Response to Comments

Draft Remedial Investigation and Feasibility Study

Jeld Wen Cleanup Site Everett, WA

Washington State Department of Ecology
Northwest Regional Office
Lacey, Washington
December, 2021

Figure 1. Comparison of dioxin/furan patterns in inlet sediment and Woodlife soil

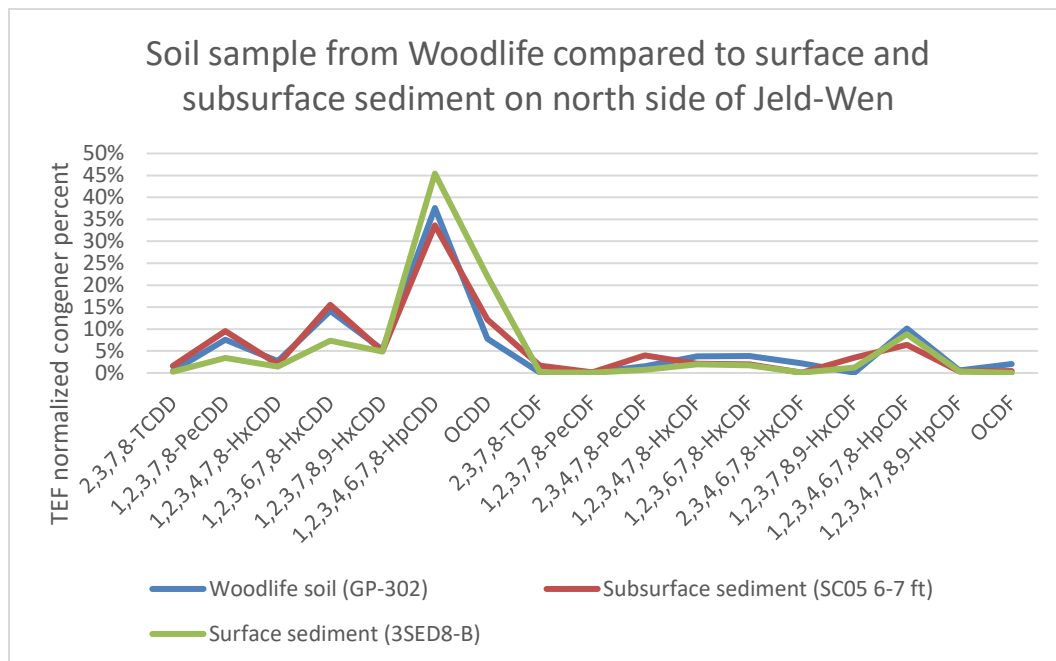
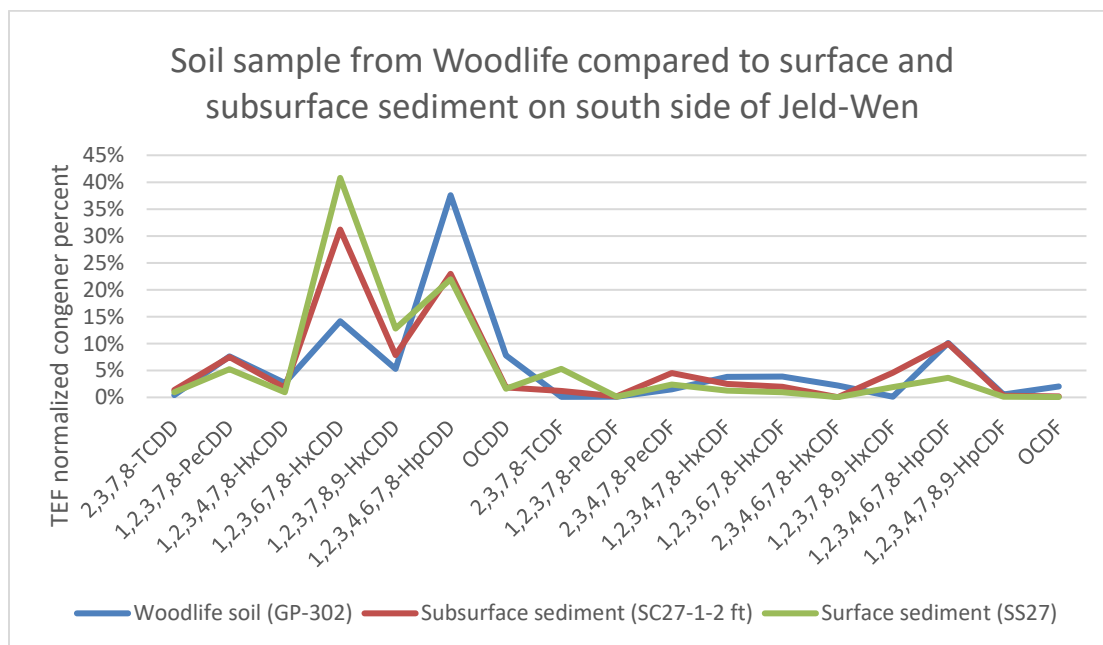
The congener patterns of dioxins/furans in soils and sediments within the inlet suggests that the patterns in sediment are consistent with the pattern in soil in the Woodlife area. The patterns in both the soil and sediment samples from the Woodlife area are dominated by the contribution of 1,2,3,4,6,7,8-heptachlorodibenzo-*p*-dioxin (HpCDD) (Figure 1). It is also important to note that the patterns in both surface and subsurface sediment in the inlet are similar

(i.e., HpCDD dominated), suggesting a continuing source. The eroding bank should be characterized during design.

Samples with elevated dioxin/furan TEQs from sediment near outfalls south of the Site had a different pattern (Figure 2). Both the surface and subsurface sediment patterns had greater contributions from 1,2,3,6,7,8-hexachlorodibenzo-*p*-dioxin. It would be helpful to compare this pattern with that of upland sample SS-301, which is a boiler ash sample. However, the congener data for this sample are not provided in Table 5.3-1. These results should be added.
